Brunson Acres

City Plan Commission — July 31, 2025

CASE NUMBER/TYPE:	SUSU25-00055 – Major Combination
CASE MANAGER:	Myrna Aguilar, (915) 212-1584, AguilarMP@elpasotexas.gov
PROPERTY OWNER:	Deering and Domenica Brunson
REPRESENTATIVE:	Del Rio Engineering, Inc.
LOCATION:	North of Montana Ave. and East of Rich Beem Blvd. (Extraterritorial Jurisdiction (ETJ))
PROPERTY AREA:	4.61 acres
VESTED RIGHTS STATUS:	Not Vested
PARK FEES:	Park Fees Not Required
EXCEPTIONS/MODIFICATIONS:	Yes, see following section
ZONING DISTRICT(S):	N/A property lies within ETJ

1. To waive the construction of a five (5) foot sidewalk along Square Dance Road.

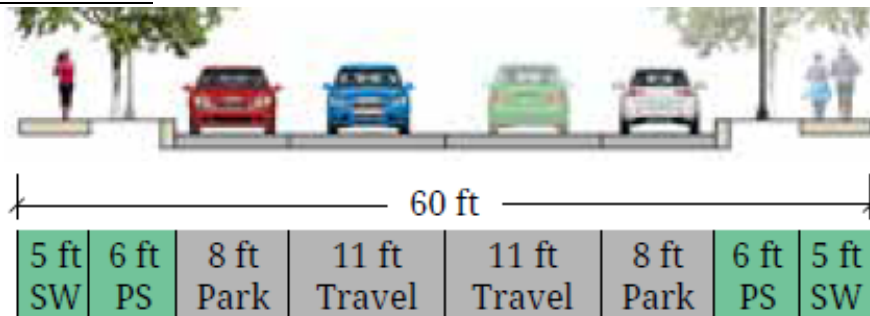
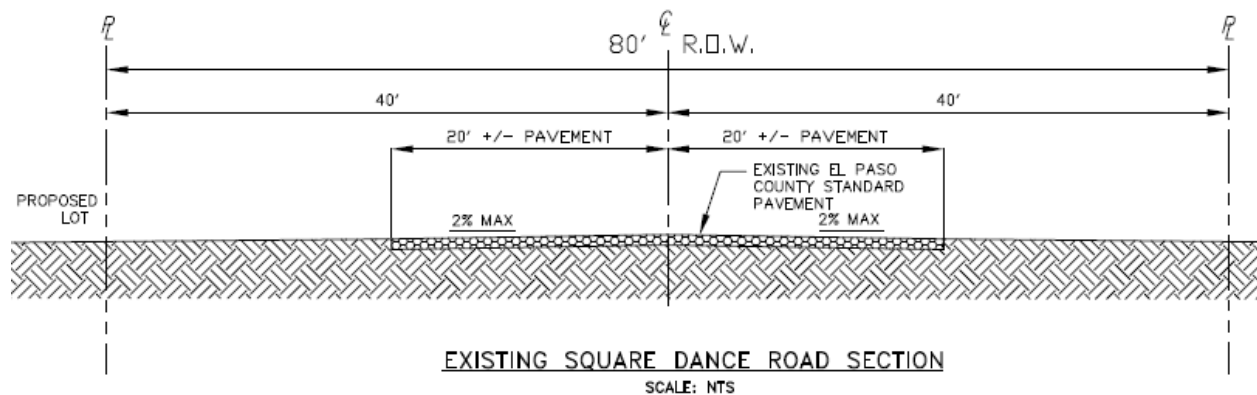
- To waive the construction a five-foot (5') sidewalk along Square Dance Road.
- To waive the construction of a five-foot (5') sidewalk and seven-feet (7') of roadway along Round Dance Road.
- To waive the construction of a five-foot (5') sidewalk and seven-feet (7') of roadway along Allemande Road.

SUMMARY OF RECOMMENDATION: Staff recommends **APPROVAL** of Brunson Acres on a Major Combination Application basis and **DENIAL** of the exception requests to waive the construction of sidewalks; Staff recommends **APPROVAL** of the request to waive the construction of additional roadway from the City Plan Commission:

Although the request for exceptions meets the waiver criteria previously stated, staff recommends denial of the waiver of the construction of sidewalks based on the following:

- Corner property providing opportunity for future connectivity
- Properties in the area including immediately adjacent are not platted
- Sidewalks will provide connectivity to a Linear Park currently under construction on Square Dance Rd.

Figure B: Developed properties within a quarter mile of proposed subdivision

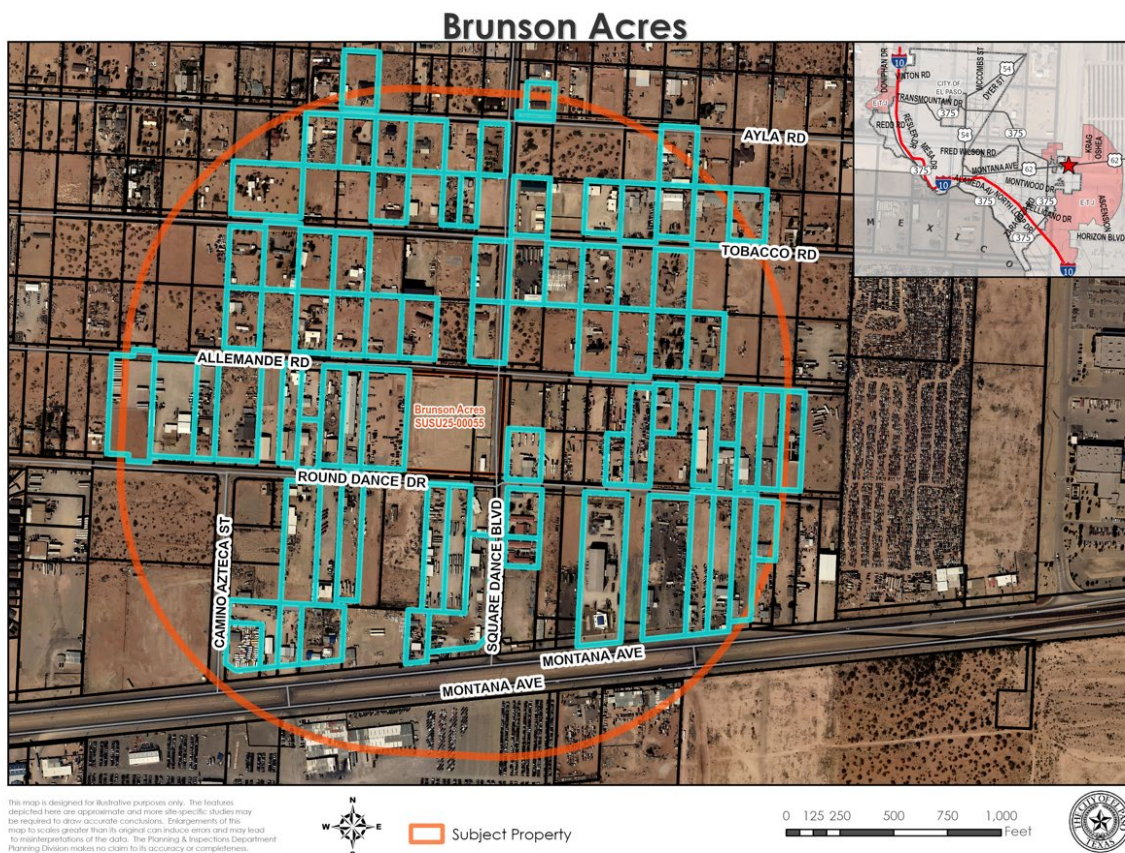
The exception request to waive the required improvements for Square Dance Road, Round Dance Road and Allemande Road meet the criteria of already developed and the existing street improvements that are in character with the neighborhood.

ATTACHMENT 2

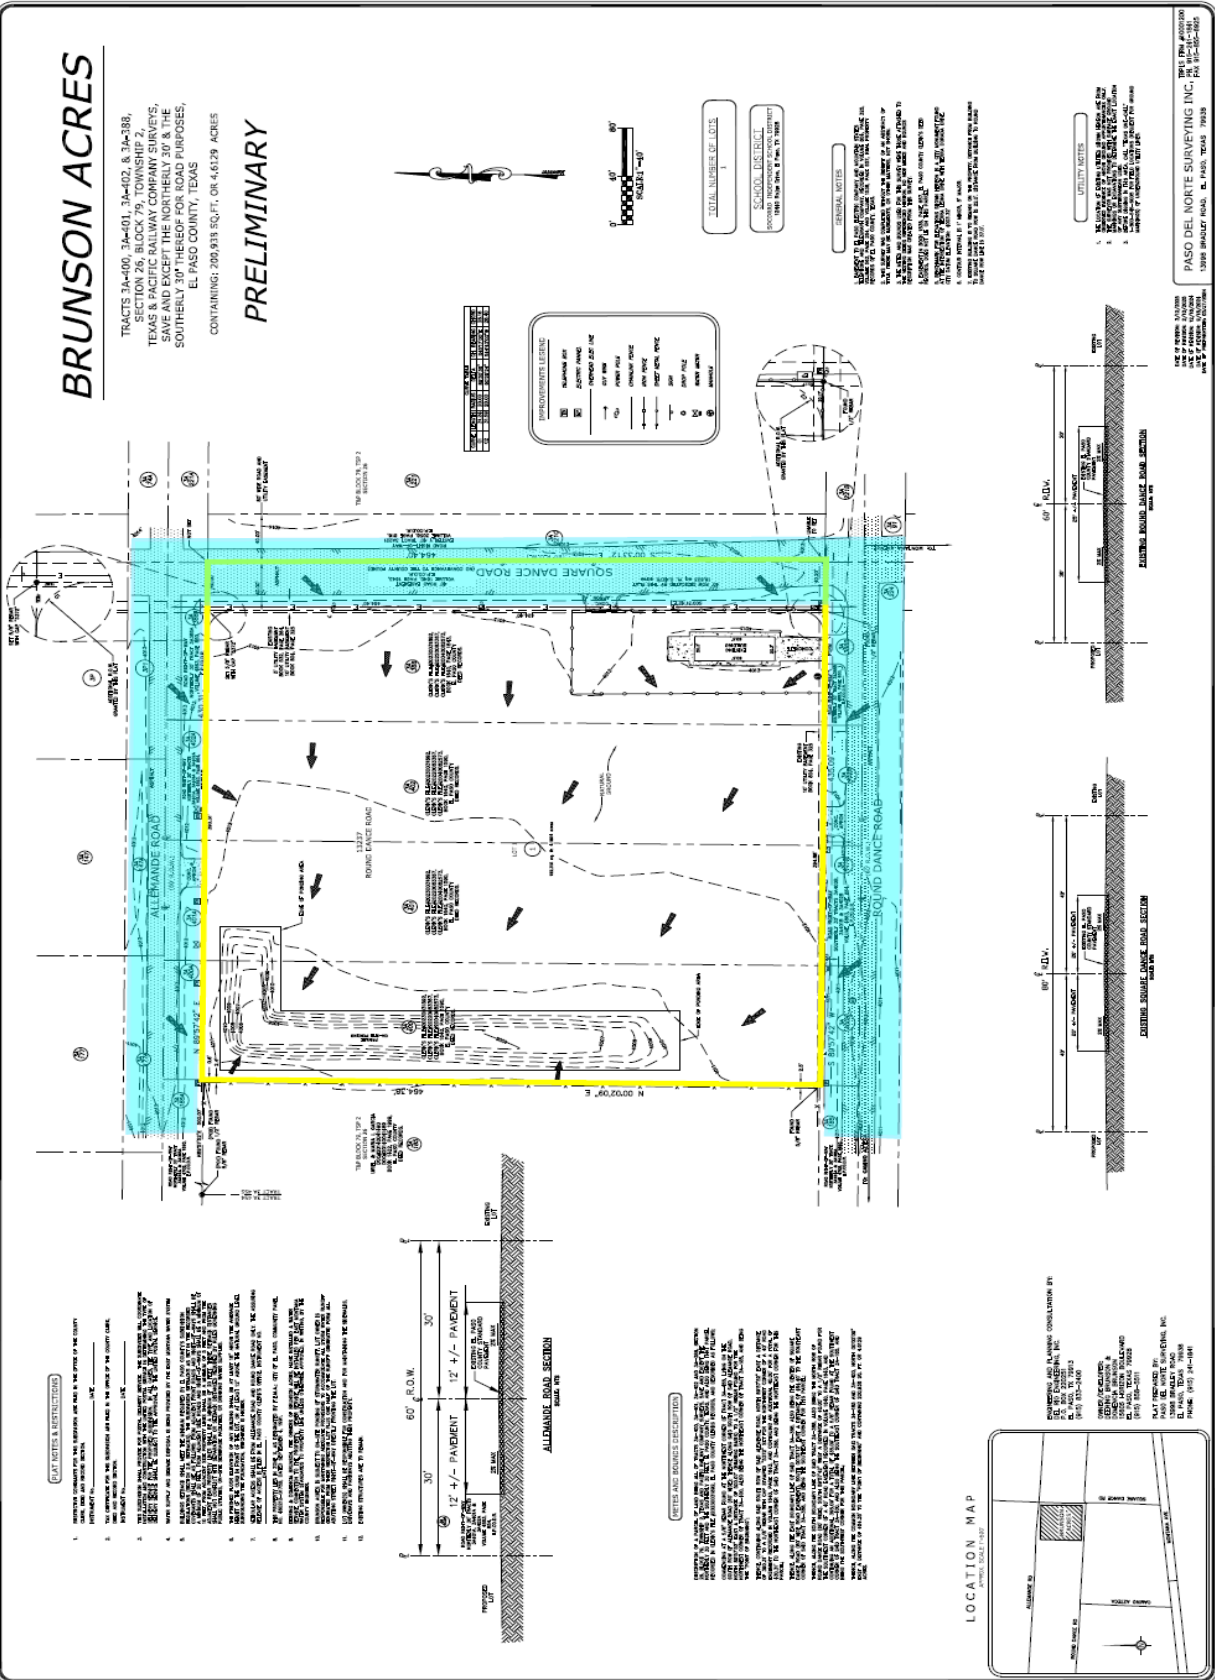
1. Dimension proposed and existing driveway widths.
2. Dimension edge of pond distance to ROW.
3. Provide complete report notes for Water, Sewage Facilities, and Drainage Report for ETJ requirements in English and Spanish.
4. Print-out of the mathematical closure provided is ok.
5. SIP plans will be required for ROW improvements.

- Correction of misspelled words
- The dedication Statement shall be modified to include the Additional rights-of-ways to be dedicated at the corners of Allemande Road at Square Dance Road and Round Dance Road at Square Dance Road to provide for turning radii to be in compliance with EP County Subdivision Regulations
- And clarification of notes "Additional R.O.W. Granted by this Plat"
- Metes and Bounds Description does not include datum base system reference, Point of Commencement, Point of Beginning no Benchmarks and reference / tie information
- Proposed Subdivision is in the City of El Paso's ETJ area and applicable ETJ statement(s) as applicable have not been incorporated in Plat sheet(s) and on all the drawings as applicable
- Plat Notes and Restrictions -
- Additional notes and/or clarification of the set of Plat Notes and Restrictions illustrated shall be

- Drainage report illustrates information for a different subdivision
- Existing current lot lay out as depicted on Preliminary Plat and Drainage Report is not as per proposed typical lot layout illustrated on Drainage Report

- Street cross sections shall be modified to illustrate the proposed improvements, required current Subdivision Regulations
- General notes on Preliminary Plat are not included on Final Plat, all applicable information shall be consistent on both the Preliminary and Final Plats
